REQUEST FOR PROPSAL

PROJECT #: 656-21-236		PROJECT NAME: EHRM Admin & Training	
PROPOSAL DUE DATE:		TIME DUE:	PROPOSAL SENT TO:
Tuesday January 17		12:00PM CST	thagen@mdmconst.com dnotch@mdmconst.com
PURPOSE:		PREPARED BY:	DATE ISSUED:
RFI and Bulletins		Trent Hagen	1/6/2023

ST. CLOUD VA HEALTH CARE SYSTEM
ST. CLOUD, MN.
PROJECT NAME: EHRM Training & Admin Support
VA PROJECT NO: 656-21-236
BAE NO: 18-116

CONSTRUCTION BULLETIN NO. 001

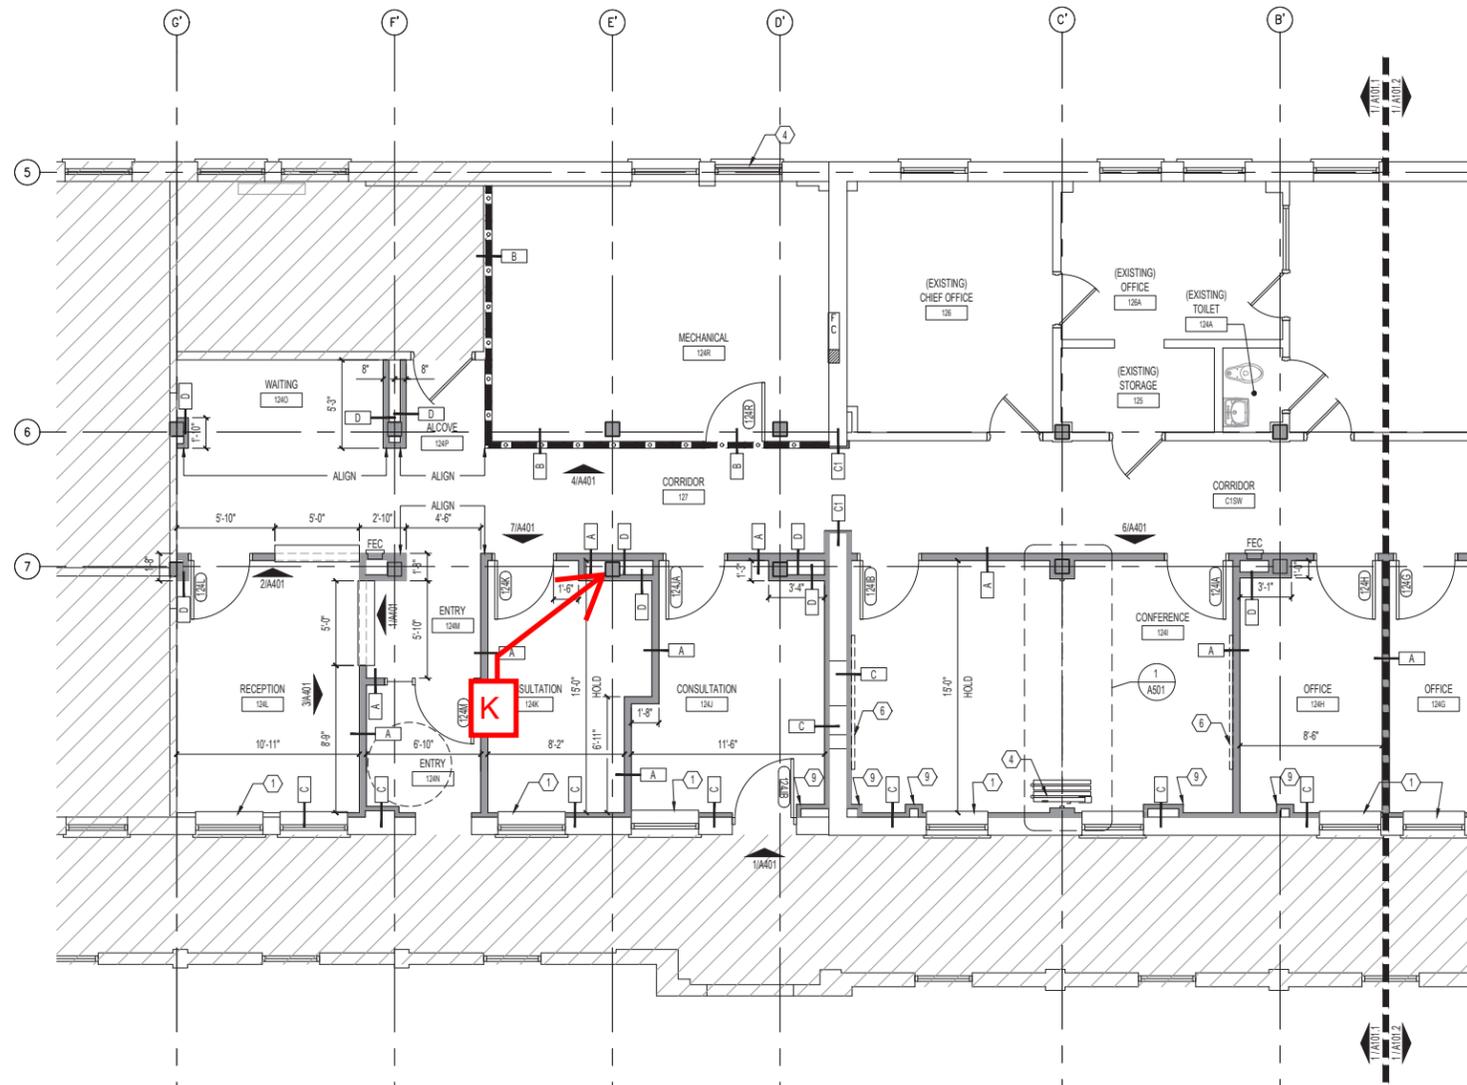
J- Possibly abandoned domestic water line. This line runs up through the floor from the basement and follows up the column. About 1' from the 2nd floor deck, this line appears to tie into pipe I. This line is cut off in the basement.

K- Appears to be a domestic cold water line. Possibly a drinking fountain on 2nd floor? This line runs up from the basement through first floor and up to 2nd floor. This line appears to be active yet. Not sure if this line impacts the new desired layout.

BAE would normally recommend only abatement of insulation on piping that will impact the contractor's ability to perform the Work. However, the VA may see value in completely abating the exposed insulation throughout in order to not have to address again on future renovation projects. Please verify with the VA as to expectation on extent of abatement work.

NORTH
1 PLUMBING - DEMOLITION PLAN - FIRST FLOOR
 1/8"=1'-0"

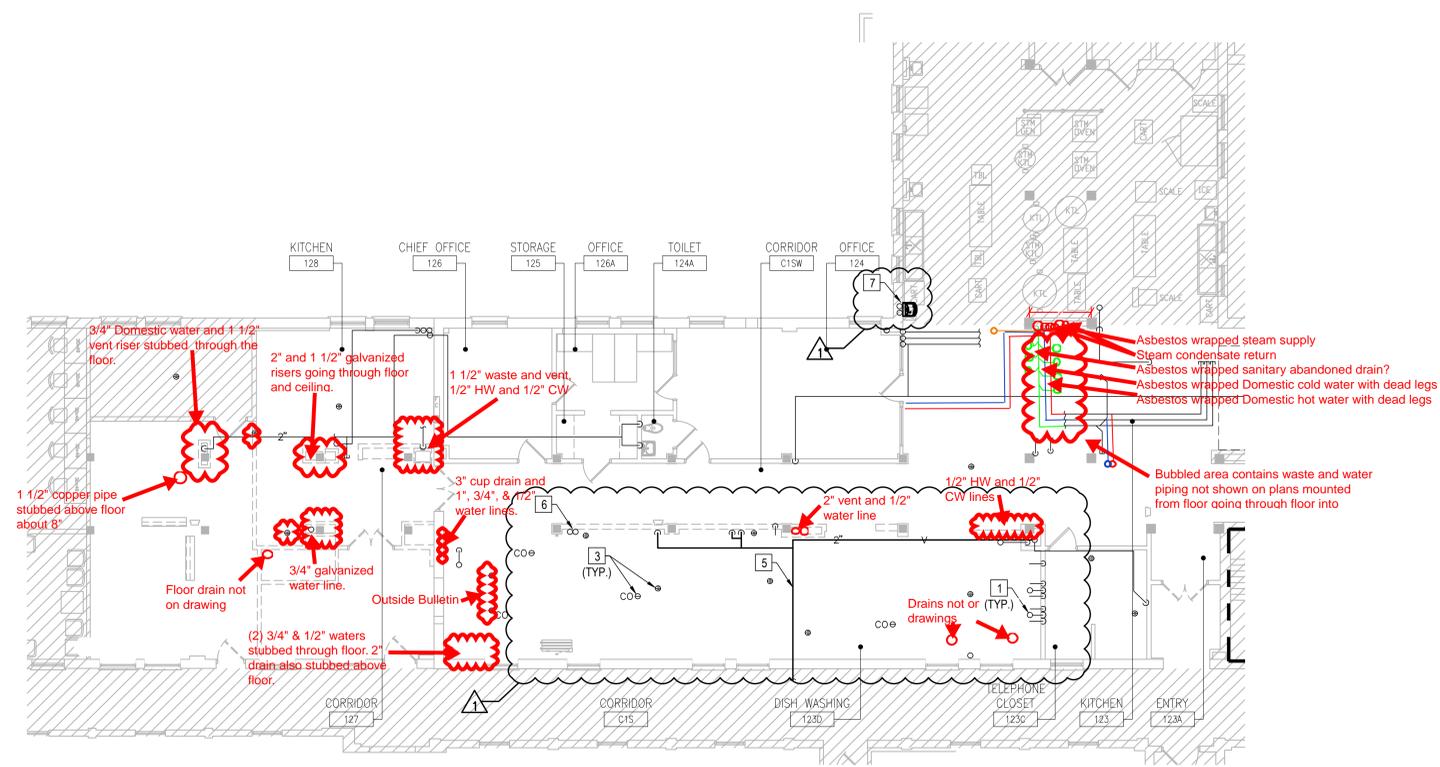
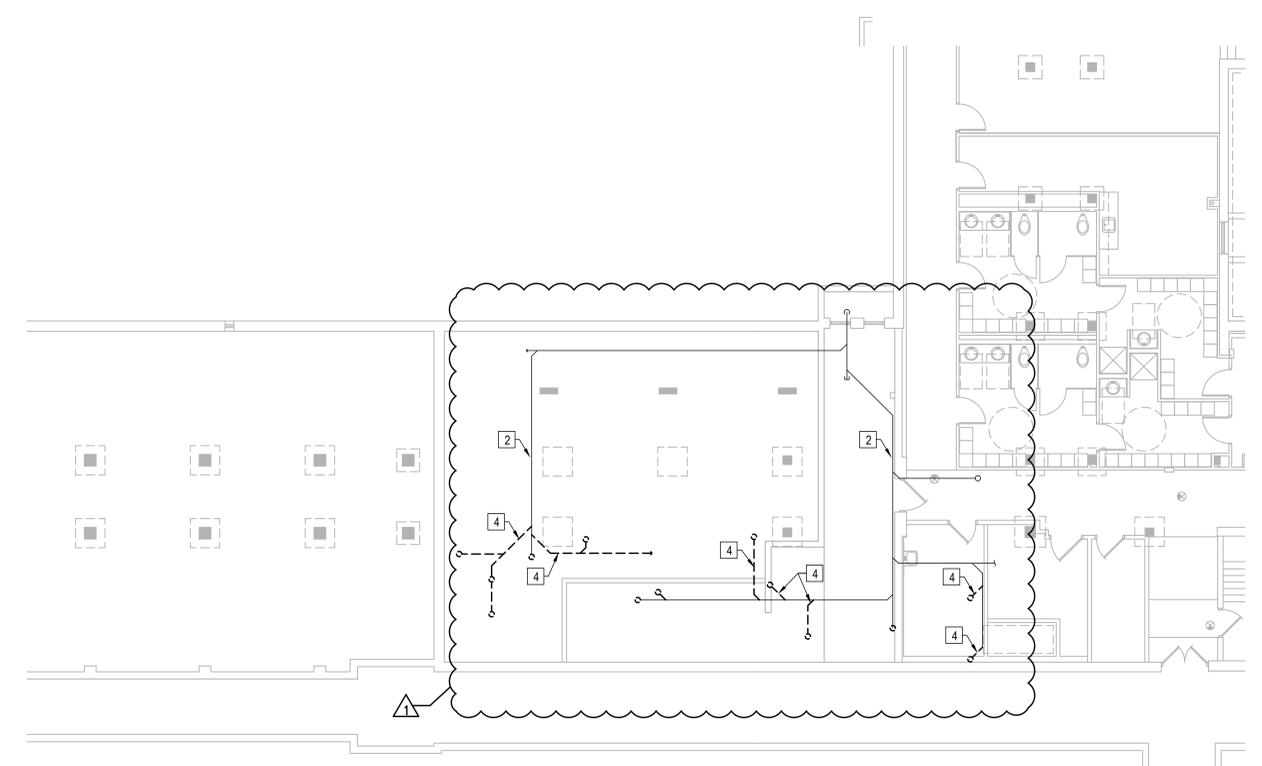
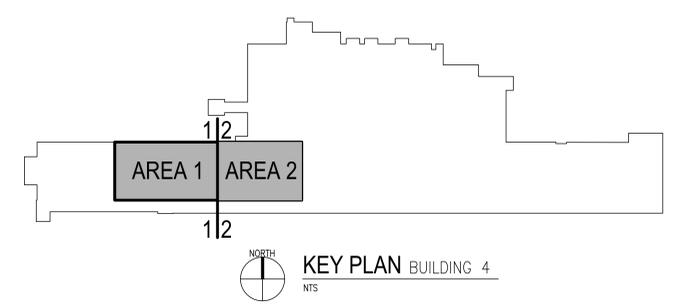
RFI:
“Please review the marked-up drawings of existing plumbing and mechanical piping found within the construction spaces once demo was completed. These drawings only show what hasn’t been captured within the Bulletin 1 drawings. Aside from the Bulletin 1 changes from the bid documents to the now known issues that were not addressed on any of the drawings. There will be additional cost implications with the Bulletin 1 updates as well as with the marked-up drawings below. There are also several dead legs that have been identified within these piping routes, most of which have been located within the ACM tagged dirt floor crawlspaces.”

Response:
BAE conducted a site investigation on October 20, 2022 on site in conjunction with Jonathan West (VCI). The team assessed the status of the pipes in question. Decisions were made by the on-site party about how to handle each pipe. Proceed as directed by COR to the field team.
